SUBJECT: Forwards addl info re reactor vessel matl surveillance
 program, analysis of Capsule V, per 861121 request.

Re: Turkey Point Units 3 and 4
Docket Nos. 50-250 and 50-251
Reactor Vessel Material Surveillance Program
Request for Additional Information
NRC TAC Nos. 62760 and 62761

ANSWERS TO NRC QUESTIONS ON
REACTOR VESSEL MATERIAL SURVEILLANCE PROGRAM
ANALYSIS OF CAPSULE V
TURKEY POINT UNIT 3

FIGURE 1

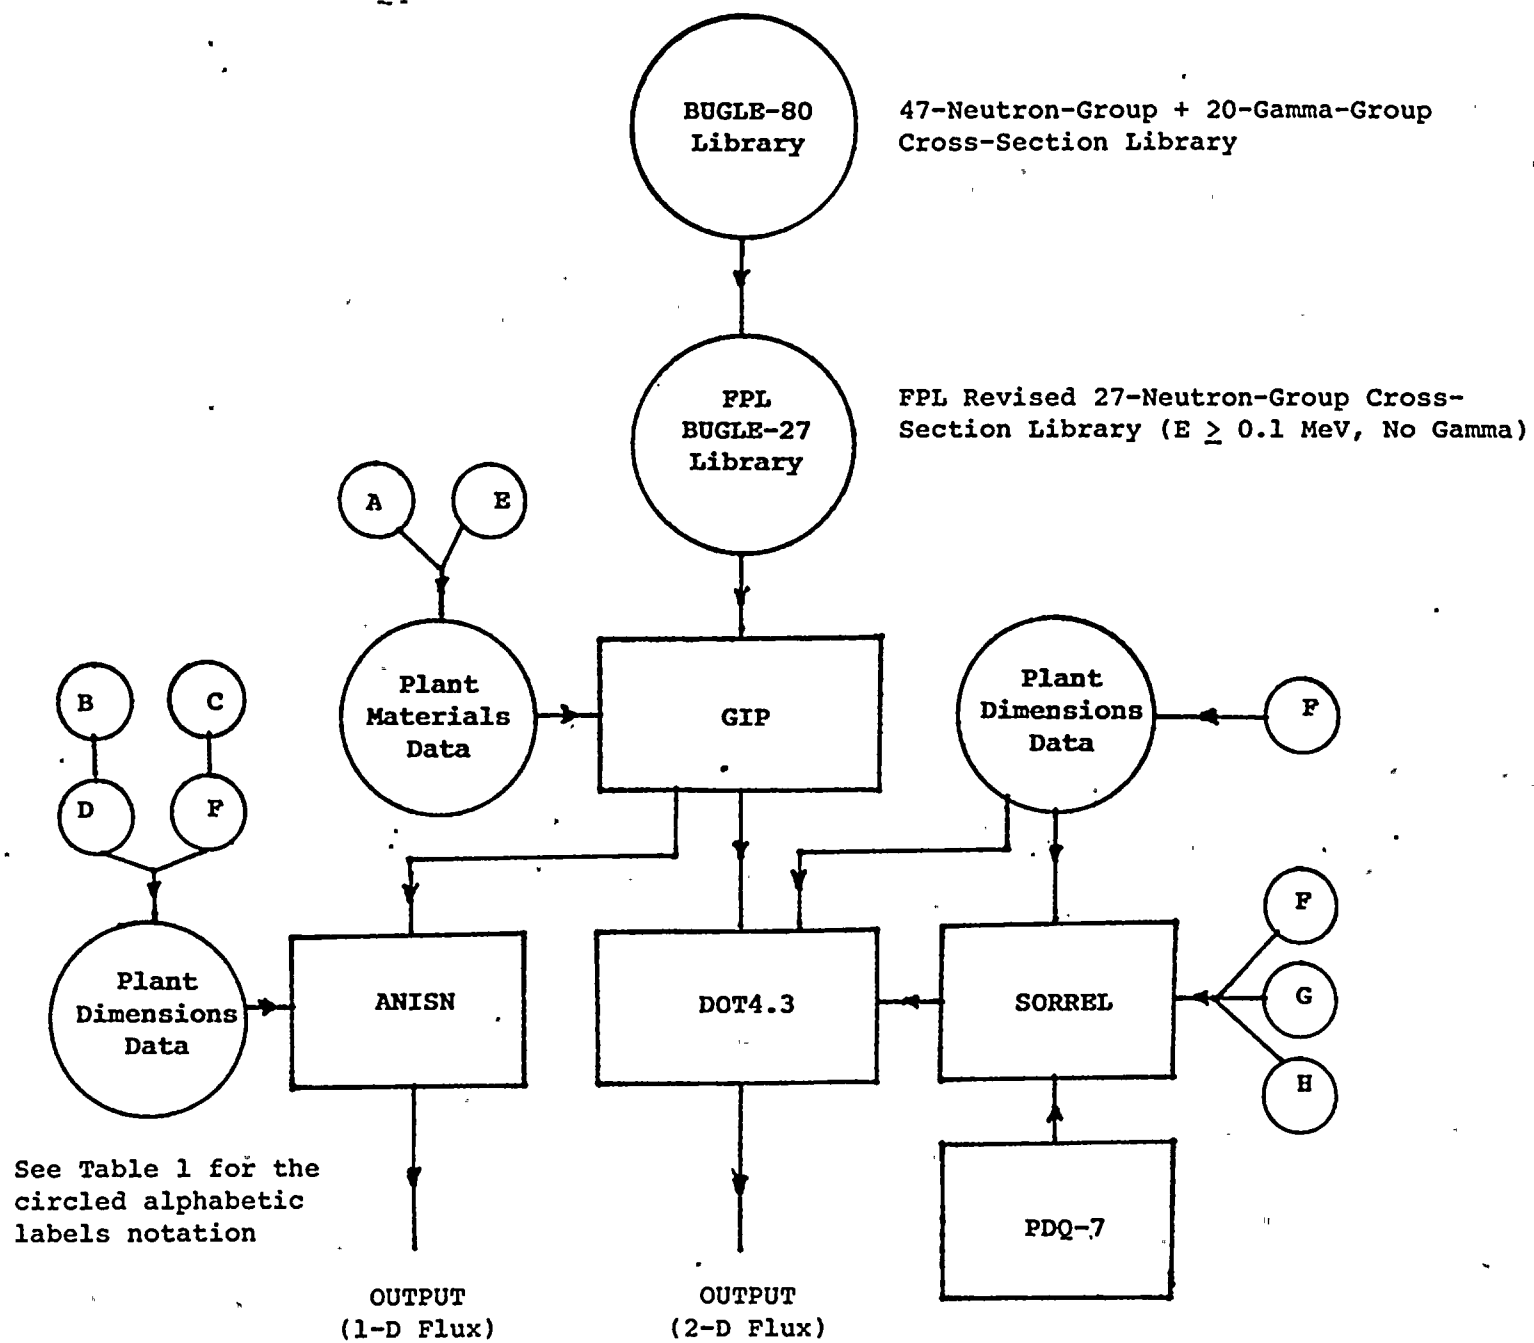
Question 3: A computational error analysis should be performed to evaluate the relative value of the computed to the measured fluence.

The error analysis provided is an estimate of the overall computational error resulting from the use of nominal input data which is subject to variability or uncertainty about its nominal value. In this analysis two reactor vessel flux calculation reference cases were established: The first reference case is a one-dimensional (1-D) transport code - ANISN case, and the second reference case is a two-dimensional (2-D) transport code - DOT4.3 case. The two reference cases utilized the nominal values of the analytical model input data.

To obtain a deviation of the nominal value of input data, a reasonable data uncertainty range was assigned to the nominal value. An additional reactor vessel flux calculation with new input data (nominal value + data uncertainty) was performed to determine new vessel flux data.

A comparison of the new calculated and reference calculated vessel fluxes was made to obtain the computational vessel flux data uncertainty.

Figure 1 shows a standard vessel flux calculational flow-chart with alphabetic labels for identification of the input data uncertainty studied. Table 1 lists each alphabetic label associated with the actual input data uncertainty. The last column of Table 1 indicates the computed vessel flux variation over the reference vessel flux data. An overall computational vessel flux error was found to be $\pm 27.5\%$. Table 2 presents conditions for the two reference cases. It should be pointed out that the above vessel flux uncertainty analysis was based on a single cycle burnup average core power data. Since analytical methodologies for vessel flux calculations of different fuel cycles are identical, the calculated $\pm 27.5\%$ vessel flux error is applicable to cycles 1 through 9.

FIGURE 2

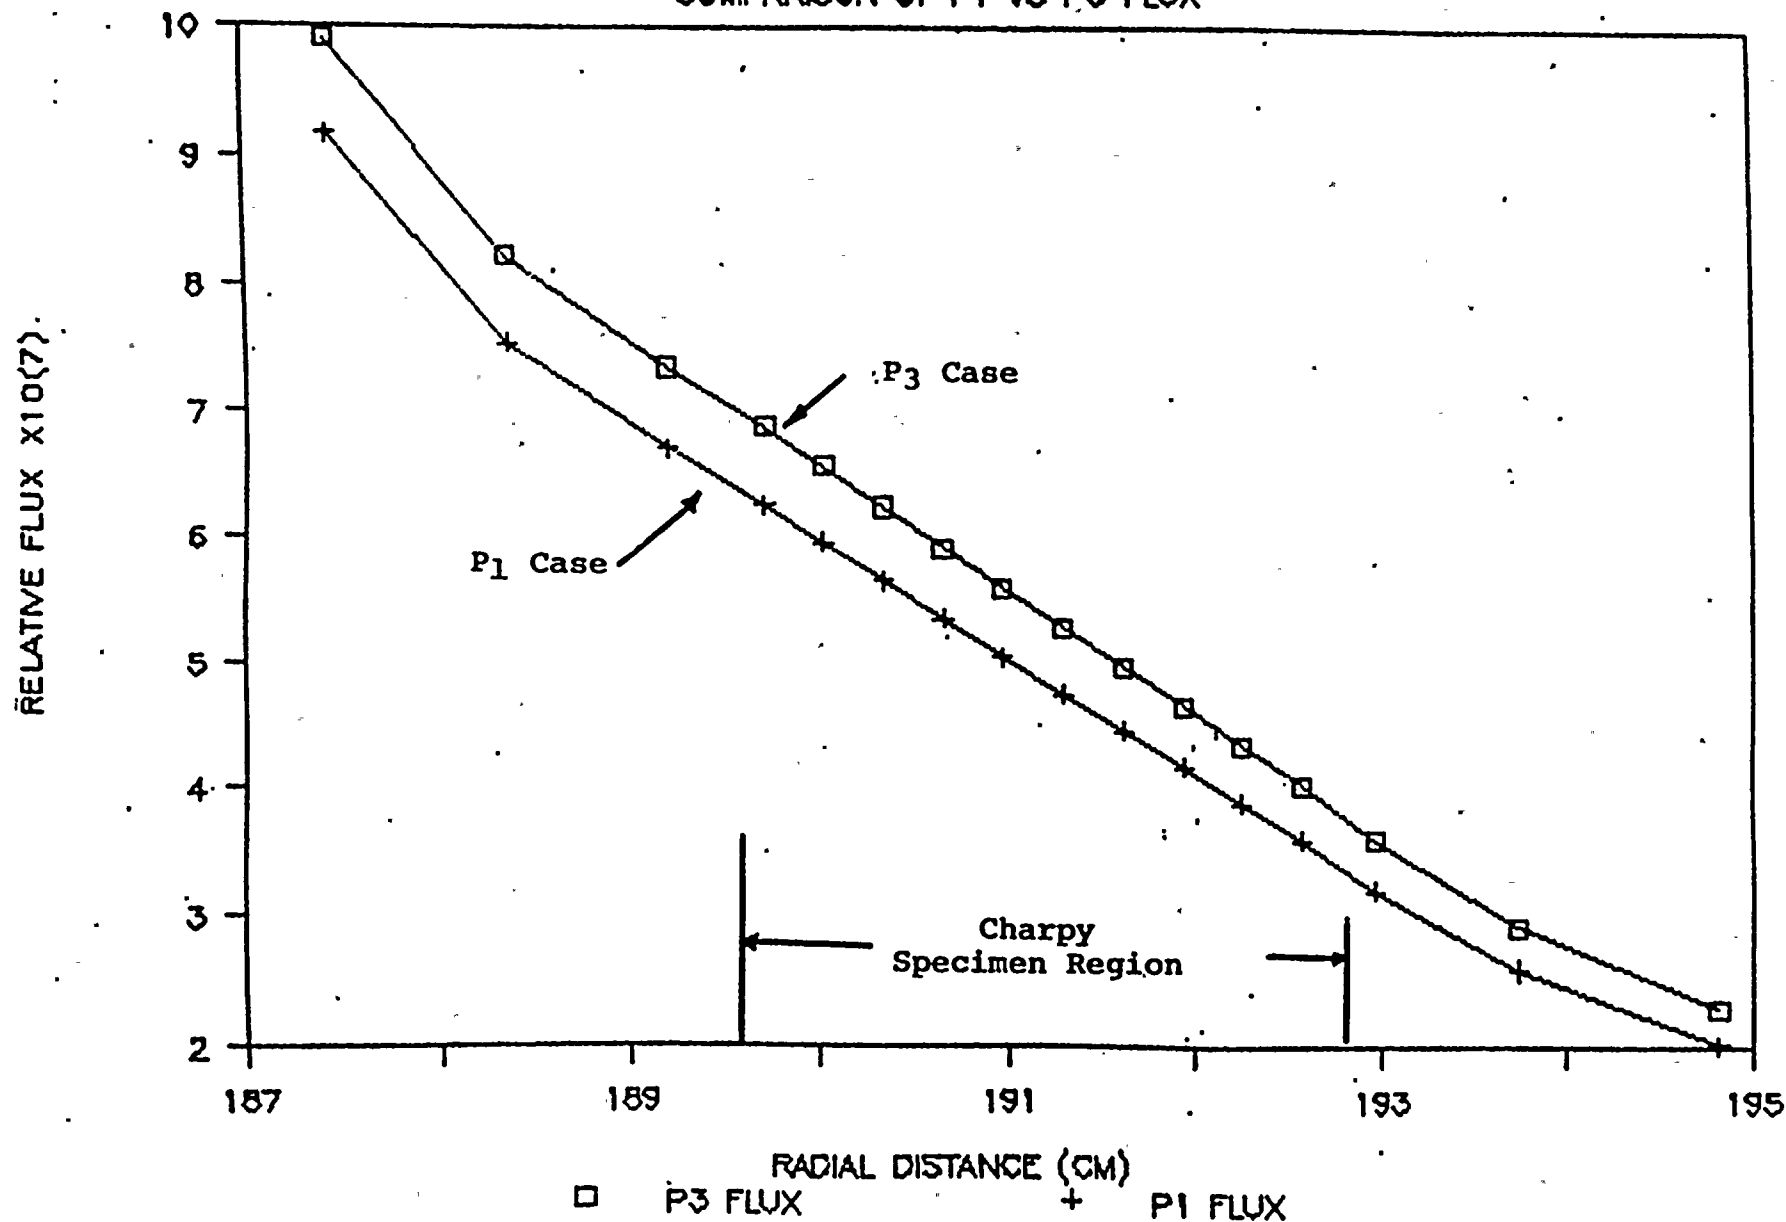
Question 4: Justify the use of the P_1 approximation.

An independent Capsule V neutron fluence analysis using the industry accepted P_3 approximation was performed by FPL for the purpose of evaluating the measurement results reported by SRI, which relied on a lower order P_1 cross-section approximation.

The cumulative fluence results reported by SRI were derived from several factors of which only the radial flux gradient correction factor inside Capsule V and the effective spectrum-averaged dosimeter reaction cross-section depend upon the P_1 approximation. The other factors are either dependent upon direct measurement or industry accepted constants.

Figure 2 shows the neutron flux distributions resulting from the P_1 and P_3 cross-section approximation analyses. The effect of the higher order cross-section approximation becomes evident in the capsule region. A 12% flux increase is observed with respect to the P_1 cross-section approximation case. However, the radial flux gradients inside the capsule region are almost the same for both the P_1 and P_3 cases. The reason for this is that the surveillance capsule is sufficiently far from the source of neutrons that the bias between the P_1 and P_3 approximation for all practical purposes is constant in the Capsule V region.
